MONITORING YEAR 5

MOORES FORK STREAM MITIGATION PROJECT

RE: Moores Fork Stream Mitigation Project
Yadkin River Basin – CU# 03040101
Surry County, North Carolina
NCEEP Project # 94709
Contract No. 6500

Wildlands Engineering, Inc. (Wildlands) has reviewed the Division of Mitigation Services (DMS) comments from the Draft Monitoring Year 5 report for the Moores Fork Stream Mitigation Project. The following Wildlands responses to DMS's report comments are noted in italics lettering.

Figure 3.0 Current Condition Plan View (Key)
 Moores Fork Stream Mitigation Project
 DMS Project No. 94709
 Monitoring Year 5 - 2020

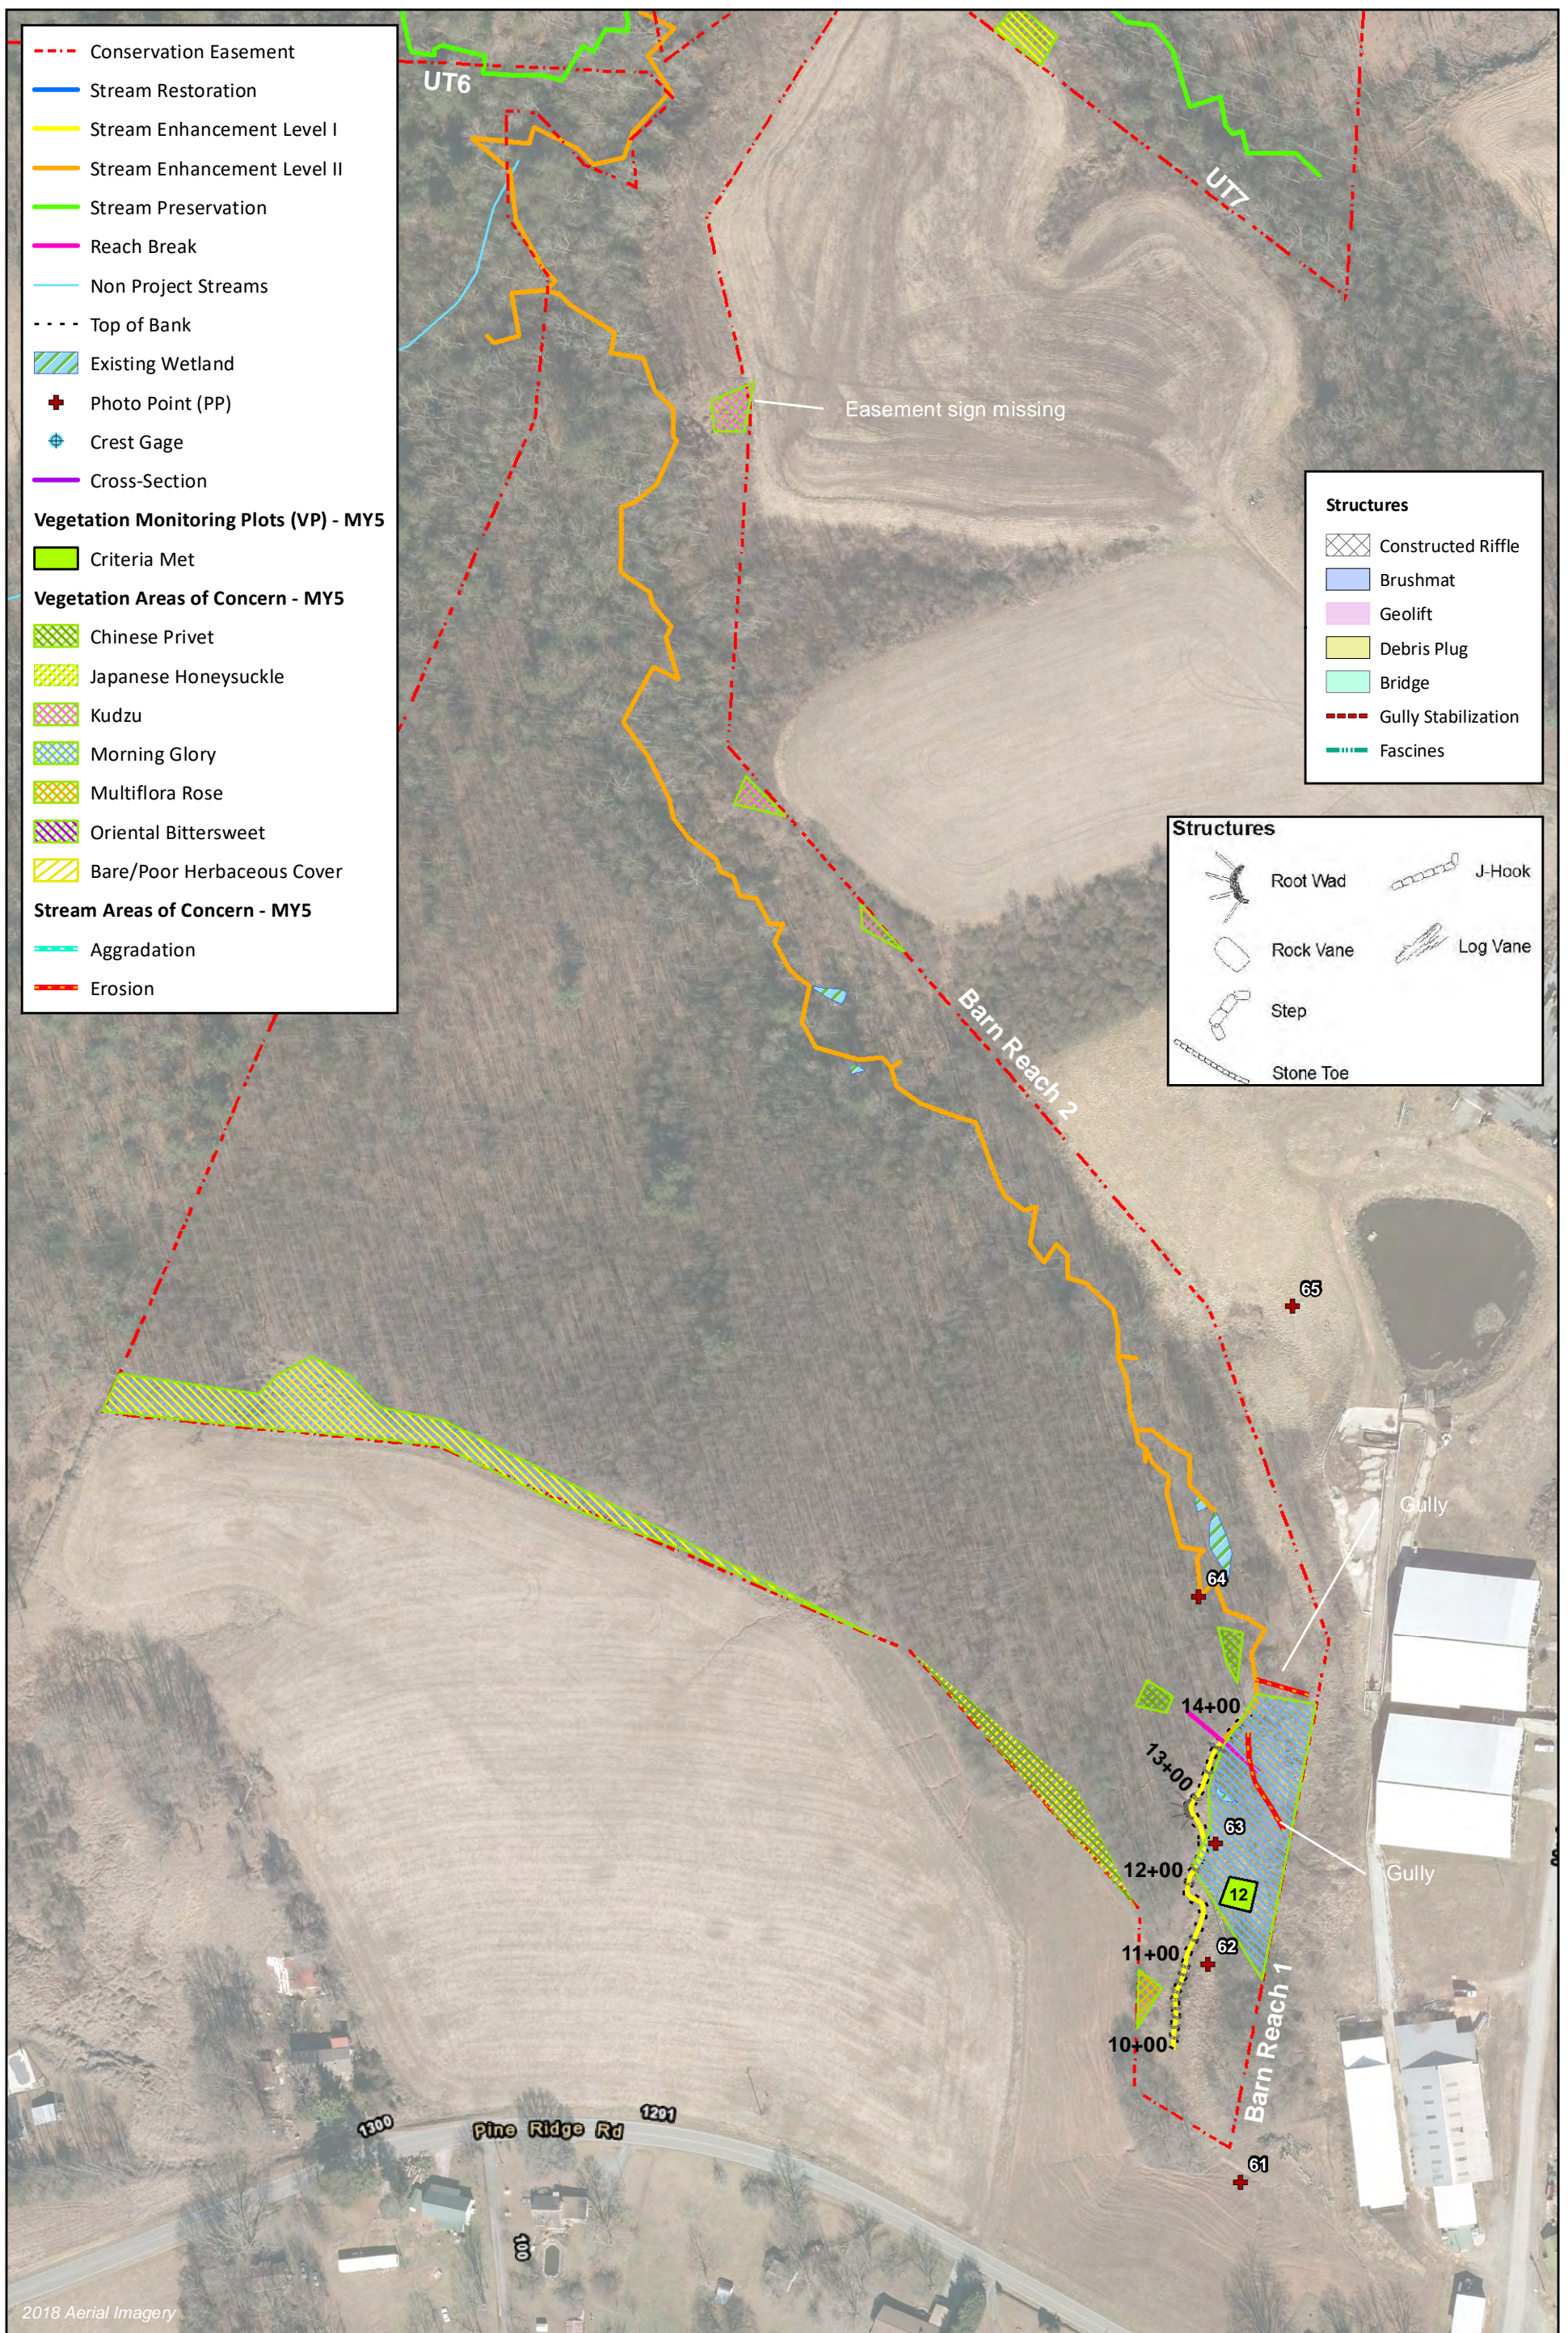
DMS comment; CCPV: Thanks for providing updated invasive species polygons. Please continue to update as treatment occurs and populations are reduced. This map is a useful tool for the contractor treating the site.

Wildlands response; You're welcome. Wildlands will continue to update the CCPV figures as treatment of invasive species occurs, and populations are reduced.
